Randwick City Council
**Kensington and Kingsford
Planning Strategy**
Stage 1 Transport Assessment

Stage 1 Report - Issue | 20 January 2017

Plan 1 – Kensington public realm and footpath upgrades

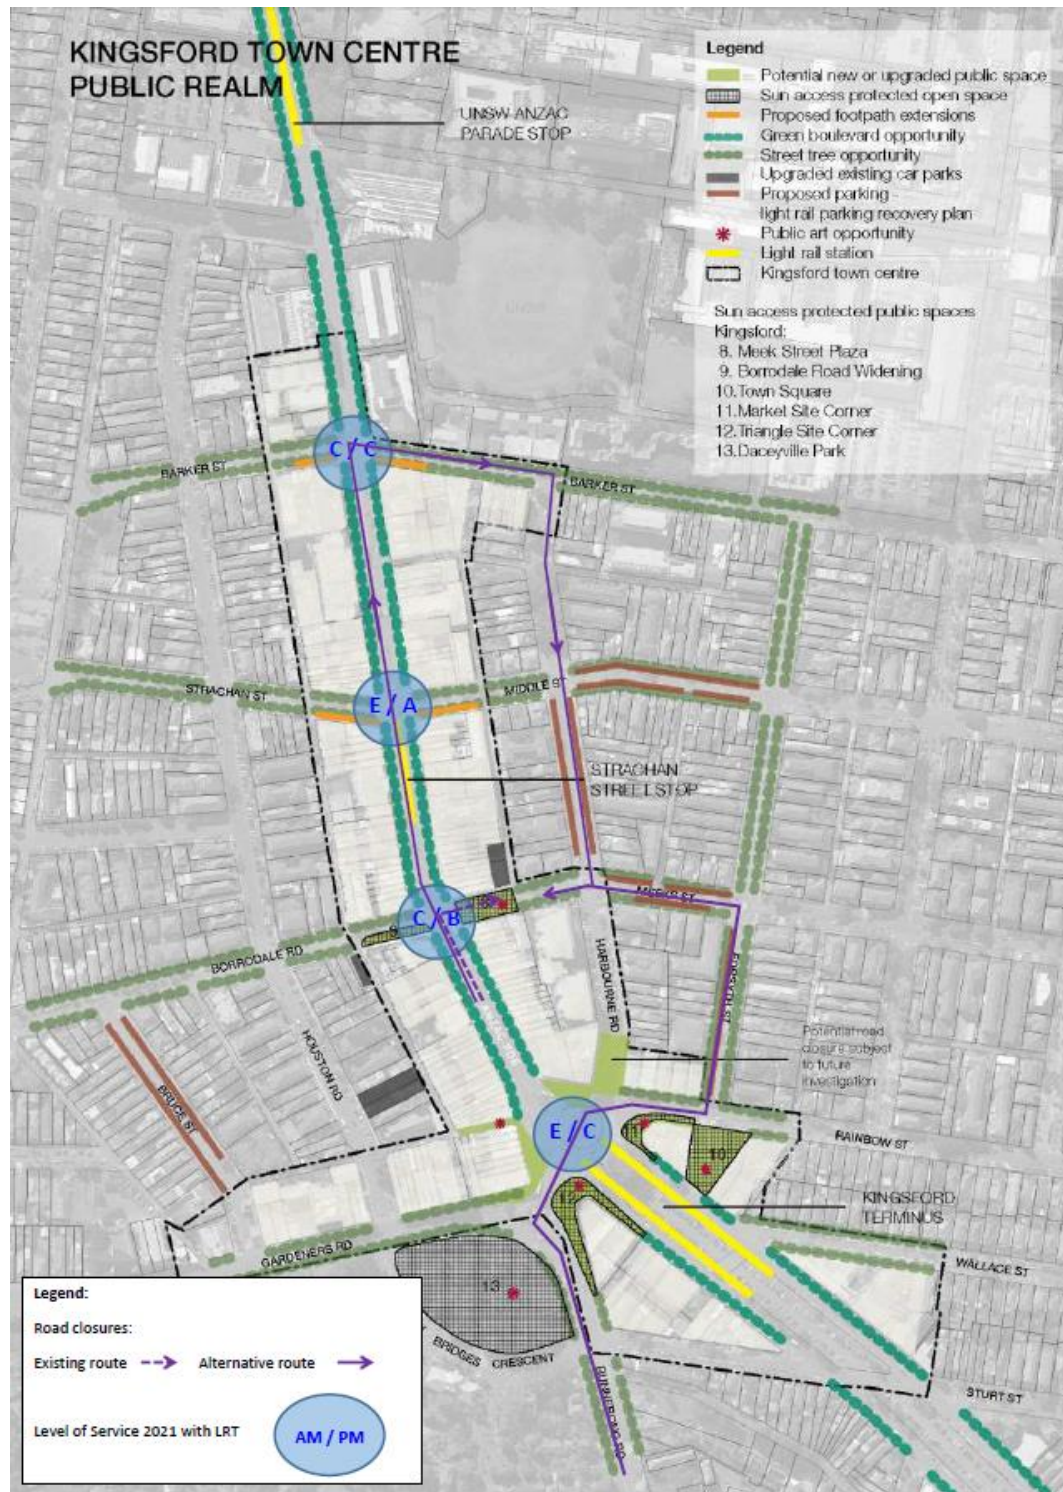
Duke Street is currently one-way westbound with left turn entry only from Anzac Parade. Alternative access is available via Kensington Street from Todman Avenue with approximately 20 vehicles per hour expected to be diverted. The existing car parking can be retained in the dead end section of Duke Street that is not part of the plaza.

Bowral Street currently has left turn entry and left turn exit at Anzac Parade. Alternative access is available on parallel east west streets to the north and south and the level of traffic diversion will low on these local streets.

There is a small car park for 9 cars including 1 accessible bay and 1 car share bay. The replacement of these car parking spaces should be factored into the wider LRT on-street car parking replacement program.

- Access to Middle Lane, the local business and the Middle Land car park will be reduced.
- Additional right turn movements will occur at Barker Street which may impact traffic capacity.

Needs to be coordinated with the Nine Ways intersection upgrade to traffic signals which will dictate the extent of plaza possible.

Needs to be coordinated with the Nine Ways intersection upgrade to traffic signals which will dictate the extent of plaza possible.

The left turn slip lane from Gardeners Rd to Anzac Parade has been retained by the RMS in the proposed traffic signal upgrade of the intersection. If the slip lane was removed it would compromise the operations of the proposed traffic signals and impact on the bus stops that are located in the slip lane. The Anzac Parade to Rainbow Street left turn slip lane is also retained in the current RMS planning, however TfNSW has agreed to the closure of this slip lane.

Harbourne Road provides left turn out traffic movement only at Rainbow Street. I would recommend retaining the Harbourne Road exit as this provides a local circulation route for traffic, particularly trucks making deliveries to businesses and cars accessing car parks and on-street spaces.

The footpath extension could be accommodated with the removal of car parking.

The footpath extension could be accommodated when the petrol station is redeveloped.

The footpath extension could be accommodated with the removal of car parking.

There are two through traffic lanes at the traffic lights and a short third left turn lane. The left turn lane could be removed to accommodate the kerb extension if modelling shows that the capacity at the traffic lights is not impacted significantly.

Widening of the footpath would be possible when the corner petrol station site is redeveloped. The existing bus stop would need to be accommodated immediately to the west of the footpath widening.

There are 2 westbound traffic lanes in Barker Street that will need to be retained for traffic capacity at the traffic lights. This footpath widening is not possible.

This footpath widening is on the entry lane and could be accommodated. The traffic lane width to be retained needs to be checked against the turning path for the largest vehicle turning right from Anzac Parade if this movement is retained after introduction of the LRT.

A footpath widening is already in place. This could be extended along Middle Street if required. Increasing the width via further extension into Middle Street would reduce traffic capacity at the traffic lights and is not recommended.

A footpath widening is already in place. This could be extended along Strachan Street if required. Increasing the width via further extension into Strachan Street is not possible due to the single entry and exit lanes already at the minimal width at the traffic lights.
